## TECHNICAL BULLETIN

[Issue No.] FA-A-0133

[Title] External appearance change and precautions regarding battery alarm detection of the MELSEC-Q series memory card

[Relevant Models] Q2MEM-1MBS, Q2MEM-2MBS

Figure 1 SRAM card

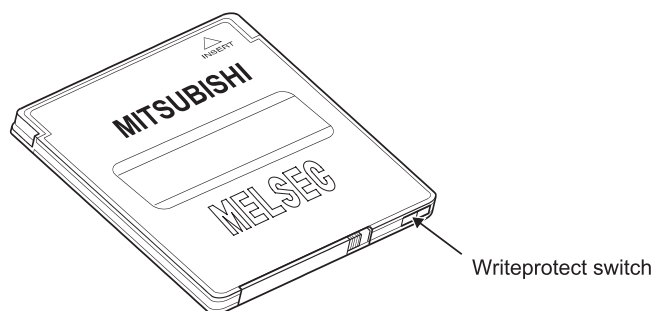
The write protect switch color of an SRAM card will be changed from black to white after the following production time (manufacturer control number: "K" or later).

There is no change in specifications due to this change.

- Q2MEM-1MBS: Manufactured in November, 2012 or later<sup>\*1</sup>
- Q2MEM-2MBS: Manufactured in December, 2012 or later<sup>\*1</sup>

**Figure 2 SRAM card back label**

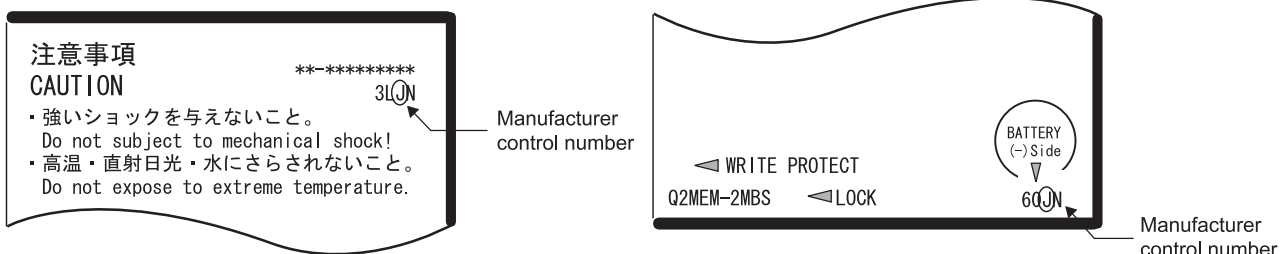
\*2: The manufacturer control number (the third digit from the left) can be checked on the top right or bottom right of the SRAM card back label.
